Addendum 1 Solicitation
23-99427
3rd Street Reconditioning

PROJECT NAME: 3rd Street Reconditioning

This Addendum is issued to modify, explain, or correct the original drawings, specifications and/or previous addenda and is hereby made a part of the Contract Documents. Please attach this Addendum to the specification and note receipt of this Addendum on the Request for Bid.

1. Signal fiber interconnect details are added and signal plans were modified.
2. Concrete pavement repair work is modified.
3. Special provisions are modified.
4. The Project Bid Form is revised.
5. Descriptions of changes to drawings are for reference only and provide only a general overview of changes made. It is the Contractor's responsibility to fully assess and provide the specific requirements of the Work on all Plan sheets regardless of the description of sheet change(s) provided herein.

SHEET NO. 11 OF 107 SHEETS

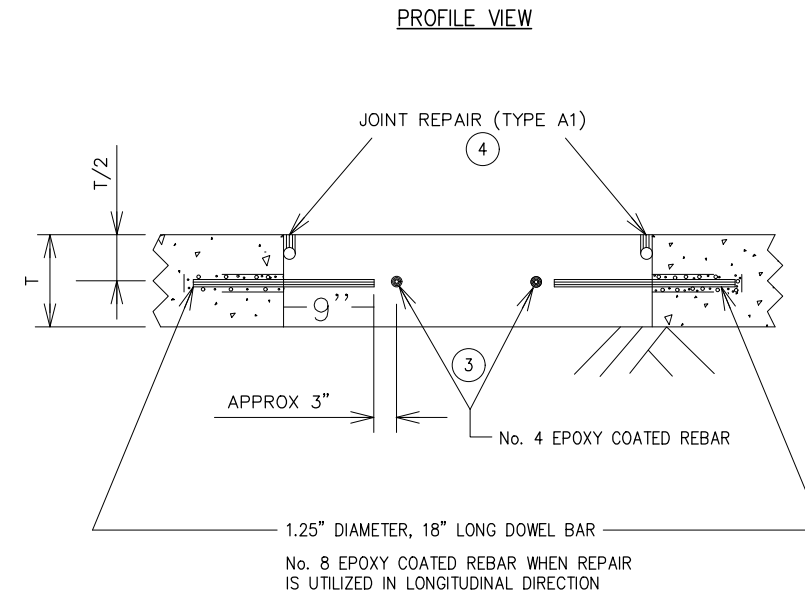
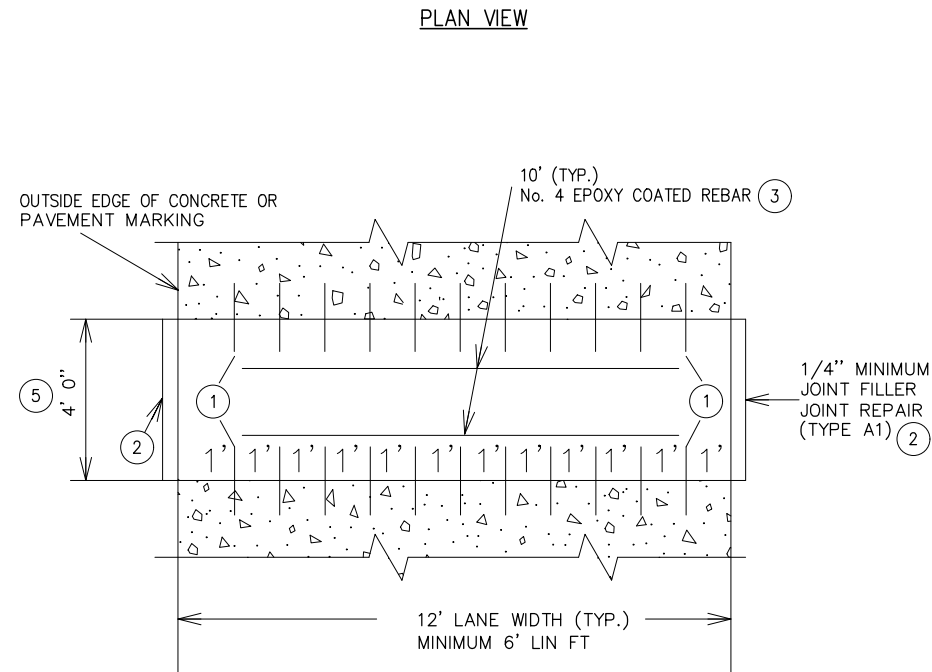
- i. Replaced item CONCRETE PAVEMENT 8.0" with PLACE CONCRETE PAVEMENT 8" in chart C.
 - b. Sheet 11; Delete Sheet 11 in its entirety and replace with revised Sheet 11. Revisions to Sheet 11 are as follows:

- i. Updated quantities and bid items in chart D
3. Sheet 38; Delete Sheet 38 in its entirety and replace with revised Sheet 38. Revisions to Sheet 38 are as follows:

SHEET NO. 38 OF 107 SHEETS

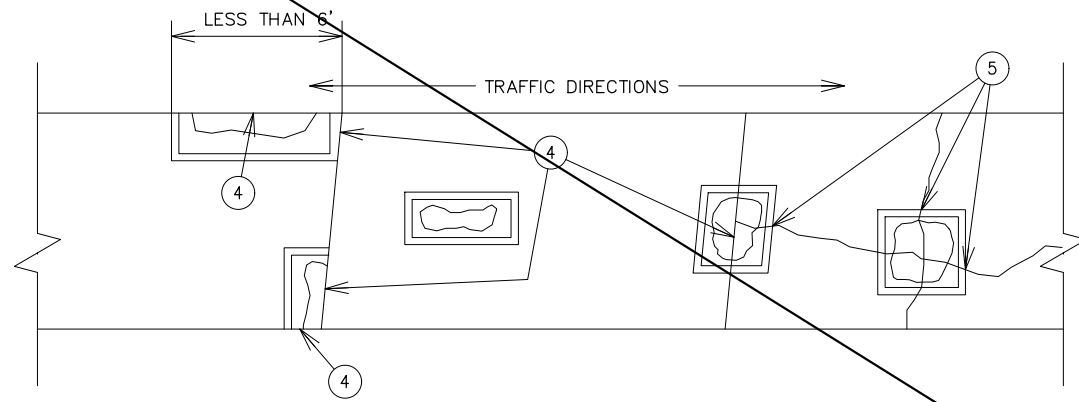
- a. Revised detail to FULL DEPTH REPAIR (TYPE CD-HV).
 - b. Added reinforcing to detail.
4. Sheet 39; Delete Sheet 39 in its entirety and replace with revised Sheet 39. Revisions to Sheet 39 are as follows:

CONSTRUCTION DETAILS
SHEET NO. 40 OF 107 SHEETS

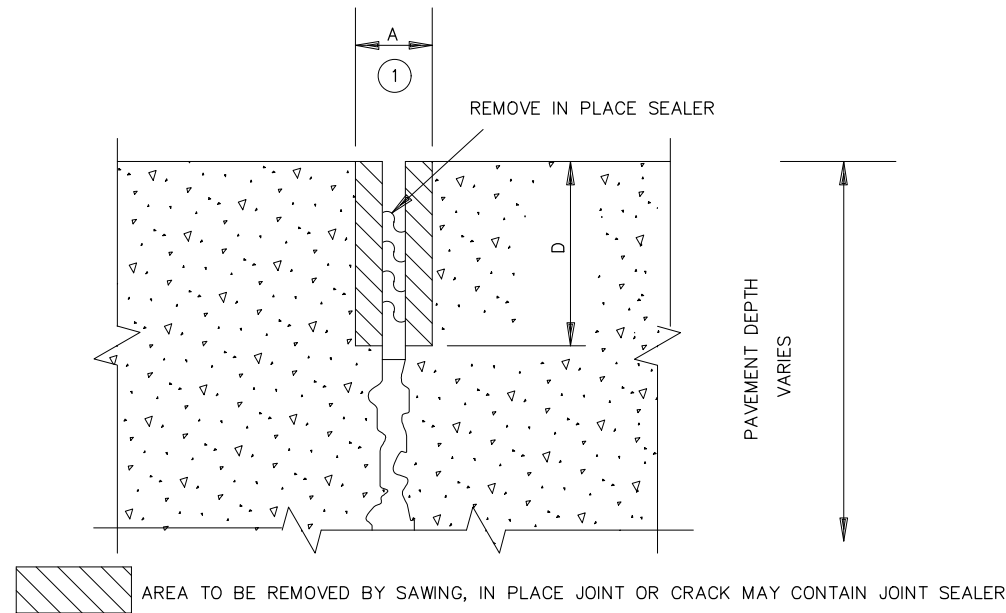
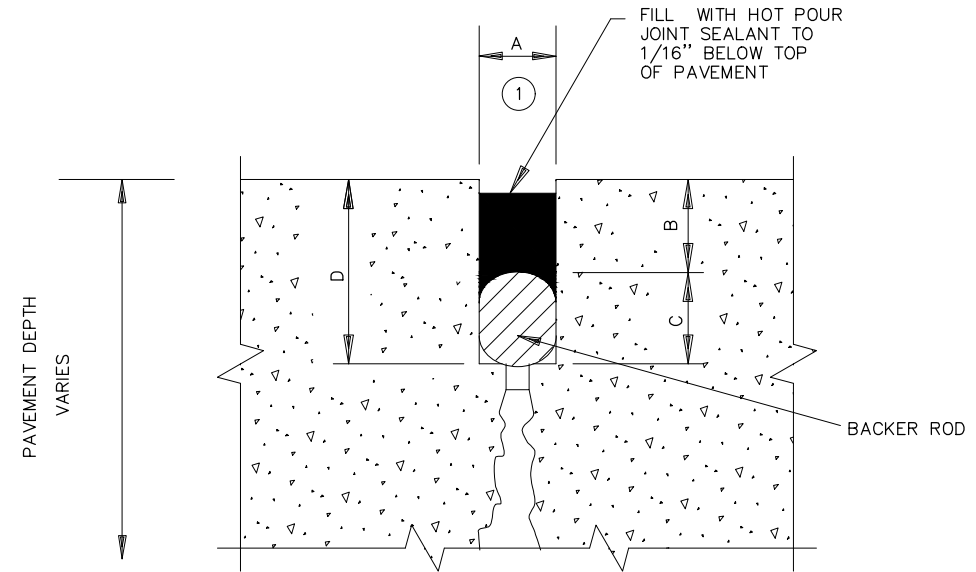
- a. Added reinforcing to detail.
5. Sheet 40; Delete Sheet 40 in its entirety and replace with revised Sheet 40. Revisions to Sheet 40 are as follows:

- a. Detail no longer applies to project and was crossed out.
6. Sheet 41; Delete Sheet 41 in its entirety and replace with revised Sheet 41. Revisions to Sheet 41 are as follows:

CONSTRUCTION DETAILS
SHEET NO. 41 OF 107 SHEETS

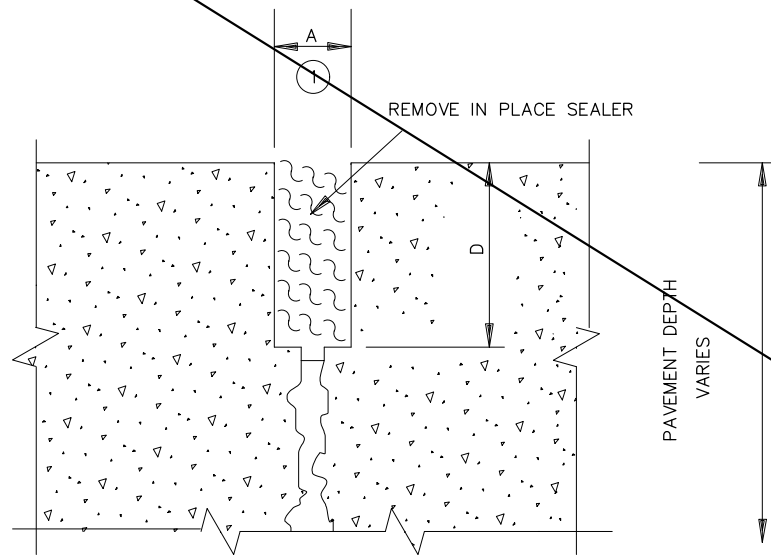
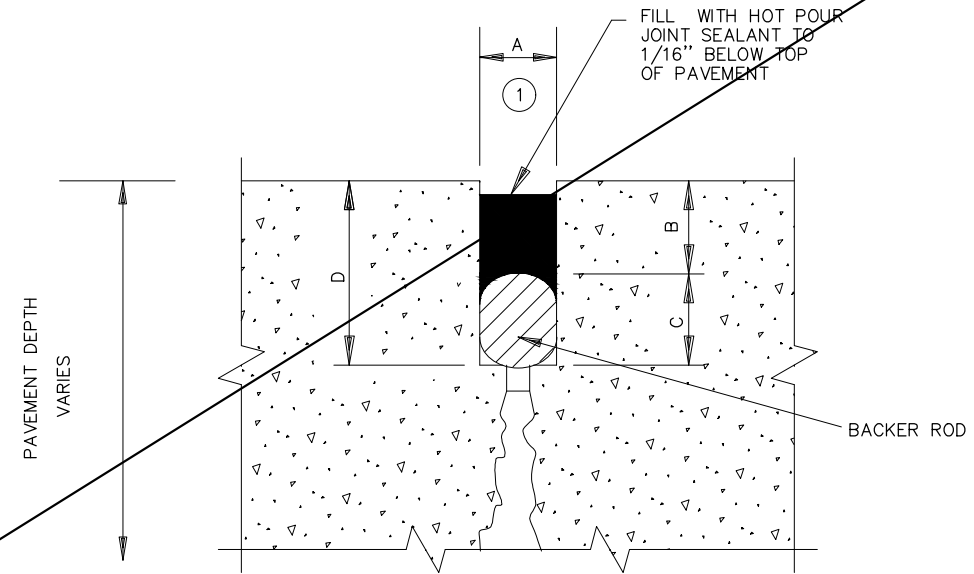
- a. Incidental to CX repair work.
7. Sheet 42; Delete Sheet 42 in its entirety and replace with revised Sheet 42. Revisions to Sheet 42 are as follows:

CONSTRUCTION DETAILS
SHEET NO. 42 OF 107 SHEETS

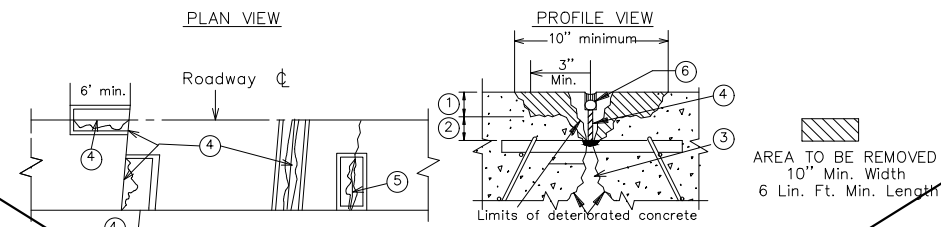
- a. Detail no longer applies to project and was crossed out.
8. Sheet 43; Delete Sheet 43 in its entirety and replace with revised Sheet 43. Revisions to Sheet 43 are as follows:

SHEET NO. 43 OF 107 SHEETS

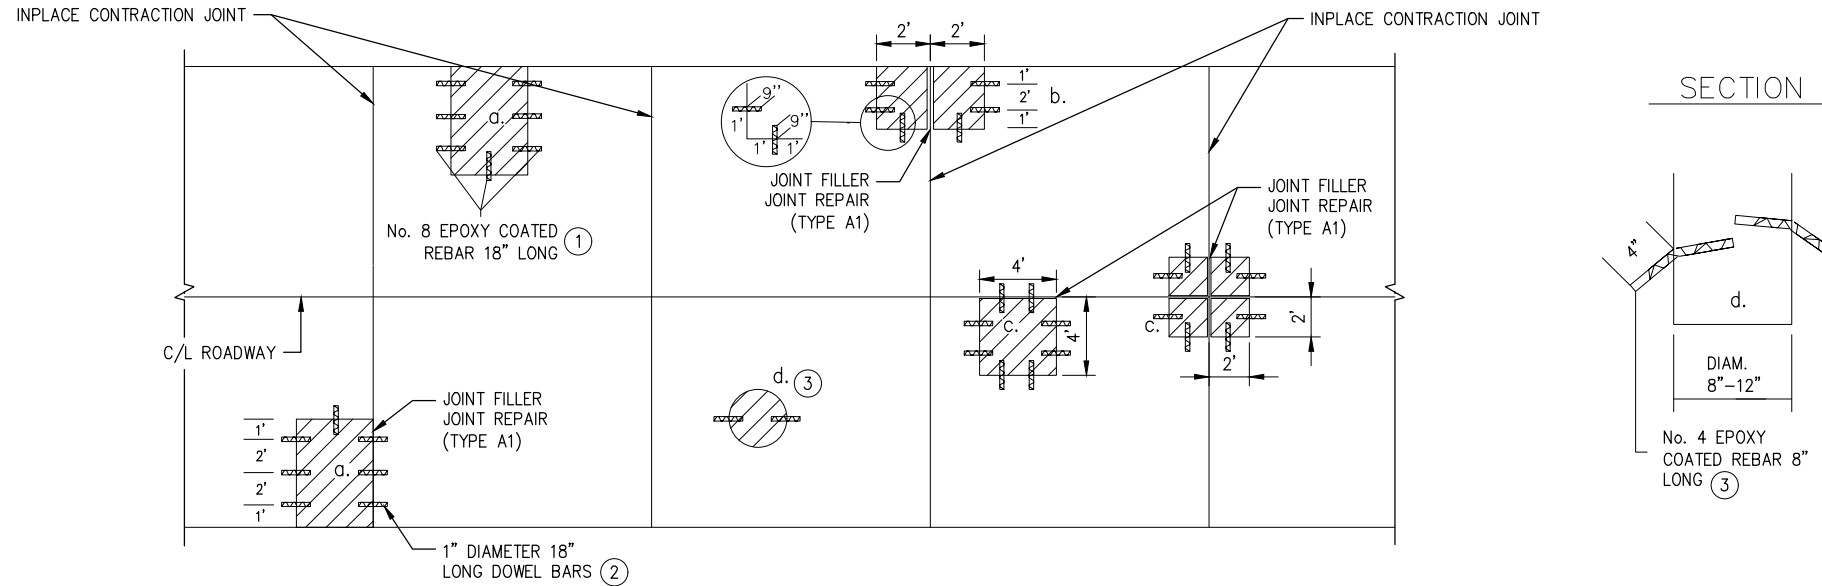
- a. Detail no longer applies to project and was crossed out.
9. Sheet 44; Delete Sheet 44 in its entirety and replace with revised Sheet 44. Revisions to Sheet 44 are as follows:
